# Technical Service Information

## MERCEDES 722.6 VARIETY OF SHIFT AND/OR TCC COMPLAINTS

Figure 1

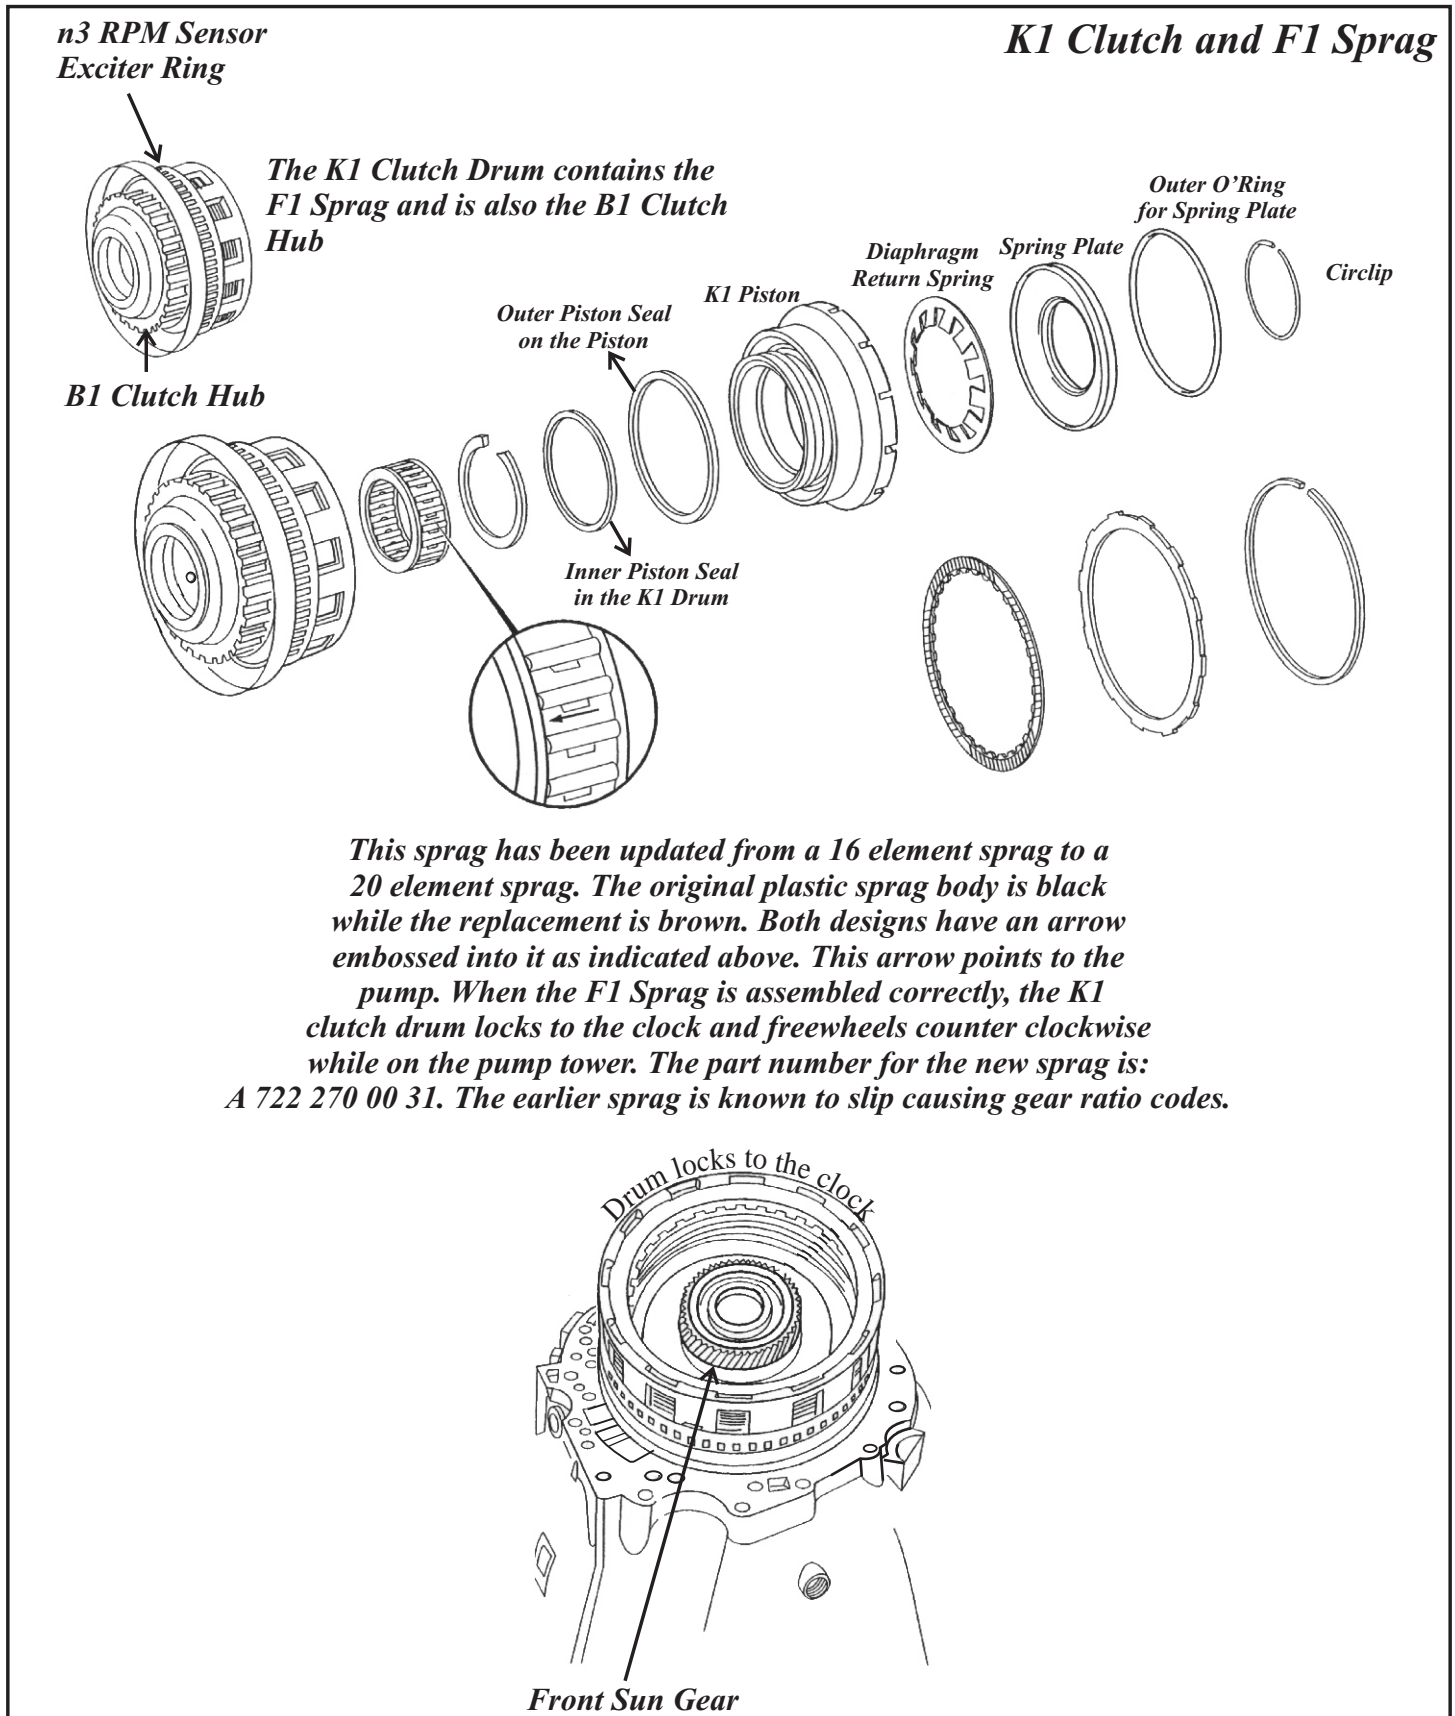
**CAUSE:** Low retention of OEM scarf cut sealing rings for the K2 clutch drum on the input shaft as well as the output shaft rings for the K3 clutch drum (See Figure 1). The rings on the input shaft could cause a loss of pressure for the K2 clutch and/or the converter clutch while the rings on the output shaft could lose K3 clutch pressure. The severity of the leak would determine the degree of shift complaints.

**CORRECTION:** Since pressure testing with a gauge is not available, it is highly recommended to update the rings to the newer style as seen in figure 1 and replace the sprags, especially if the F1 sprag has 16 elements and the F2 has 14. These are early sprags and are prone to slipping. Both sprags have been updated to 20 elements each (See Figure 2 and 3).

Figure 2

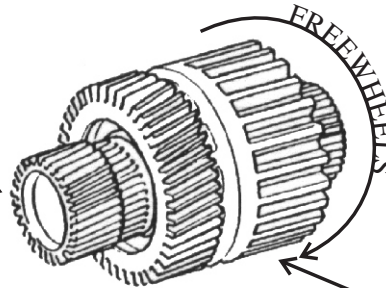
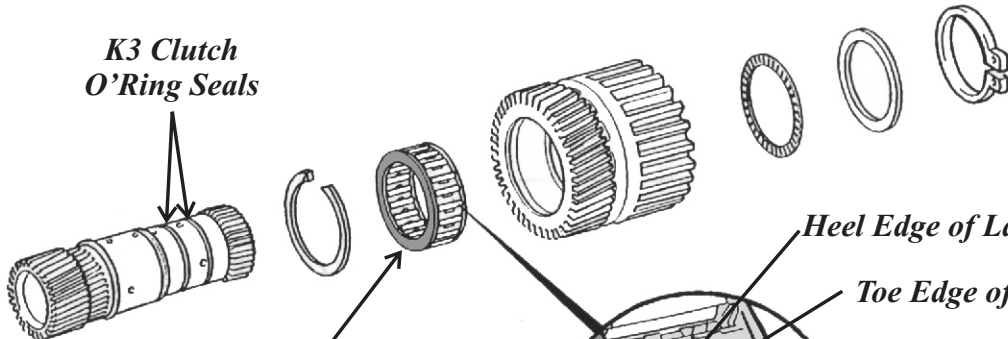
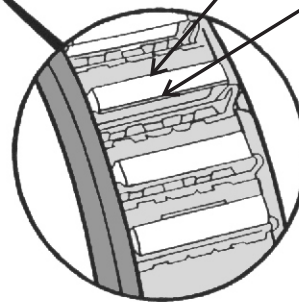
This sprag has been updated from 14 elements to 20. The new 20 element sprag part number is A 220 270 01 31. It is very common to find that some of the elements have fallen out from the retaining cage and laying loose in the package. This does not mean the sprag is defective. It is imperative that you insert the element back into the cage slot correctly. The shorter foot of the element faces the inner race as seen to the right. With the brass cap to the left as seen in the enlarged circled view, the toes face down. The early design sprag is known to slip causing gear ratio codes.
